ECE/TRANS/WP.30/GE.1/2007/15
22 October 2007

Informal Ad hoc Expert Group on Conceptual and
Technical aspects of Computerization of the TIR Procedure

WCO transit data model

WCO/DMPT – TIR DMRs

WCO LOG:	
DATE:	
User reference (*):	TRT_0003
User date:	19.06.2007

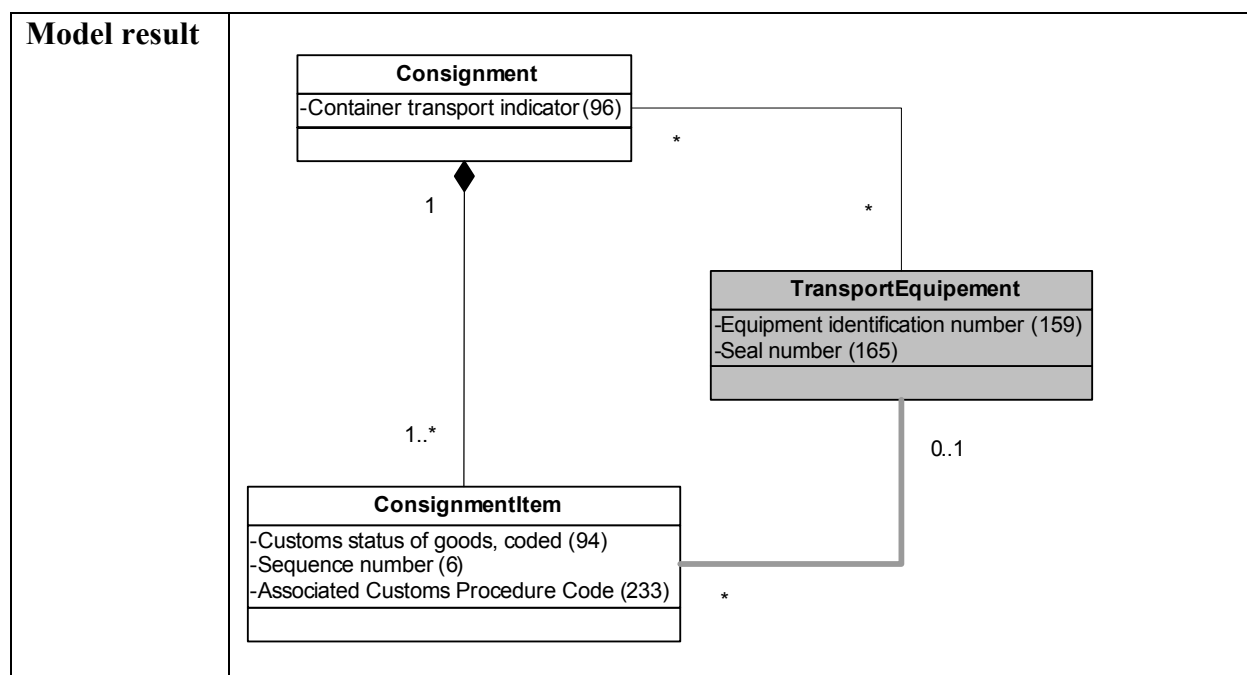
Originator (*):	DMPT_TRT
Contact person (*):	André Sceia
Email (*):	andre.sceia@unece.org
Phone (*):	+41 22 917 13 13
Data set (*):	TRT
Attached Documentation	-
Business Need/Justification (*):	A TIR transport can have multiple loading points. The goods manifest in the TIR Carnet mentions the Customs office(s) of departure . The current transit data model does not allow for declaring this information.
What process? (*)	TIR Procedure
For what purpose?(*)	The TIR procedure allows for multiple loading and unloading points in the course of the same TIR transport. The transport operator is therefore requested to declare if goods have different departures.
Based on?	TIR Convention 1975
Example.	A TIR transport begins in Geneva (Switzerland) with 10 boxes of chocolate and loads 20 additional boxes of candies in Berlin (Germany). All 30 will go to Moscow (Russian Federation).

User reference (*):	TRT_0003
MIG/Model Tag (*):	TRT
Name of MIG/Model (*):	Transit
Action (*):	Adding a “TransitDeparture” class would allow providing the information on the Customs office(s) of departure. The class should be linked with a “0:1” cardinality to the Consignment class.
Terms and Definitions	-

Oper	Posn (*)	Seg (*)/ DE (*)	Segment/ Data element Name (*)	Stat (*)	Rpt (*)	Lvl (*)	Sect
A	-	-	TransitDeparture class	-	-	-	-
Explanatory Text		Create and use in the TRT model a TransitTransportMean class.					
A	-	?	Place of departure of the transit, coded	-	-	-	-
Explanatory Text		Include a “Place of departure of the transit, coded” DE the in the TransitDeparture class (use same format and properties as DE 182).					
A	-	-	Relationship	-	0:1 0:n	-	-
Explanatory Text		Add a relationship between the TransitDeparture class and the Consignment class.					
Model result		<div style="display: flex; justify-content: space-between; align-items: flex-start;"> <div style="border: 1px solid black; padding: 5px; width: 25%;"> <p style="text-align: center; margin: 0;">TransitDeparture</p> <p style="margin: 0;">-Place of departure of the transit, coded (?)</p> </div> <div style="margin: 0 10px;">0..1</div> <div style="margin: 0 10px;">*</div> <div style="border: 1px solid black; padding: 5px; width: 25%;"> <p style="text-align: center; margin: 0;">Consignment</p> <p style="margin: 0;">-Container transport indicator (96)</p> </div> <div style="margin: 0 10px;">1</div> <div style="margin: 0 10px;">*</div> <div style="border: 1px solid black; padding: 5px; width: 25%; background-color: #f0f0f0;"> <p style="text-align: center; margin: 0;">Declaration</p> <ul style="list-style-type: none"> -Declaration name, coded (1) -Declaration reference number(2) -Message function, coded (17) -Declaration issuing date (22) -Customs office of declaration, coded (65) -Declaration issuing place, coded (82) -Total gross weight (131) -Number of seals (227) -Total number of items (228) -Authentication (104) -Amendment code (99) </div> </div>
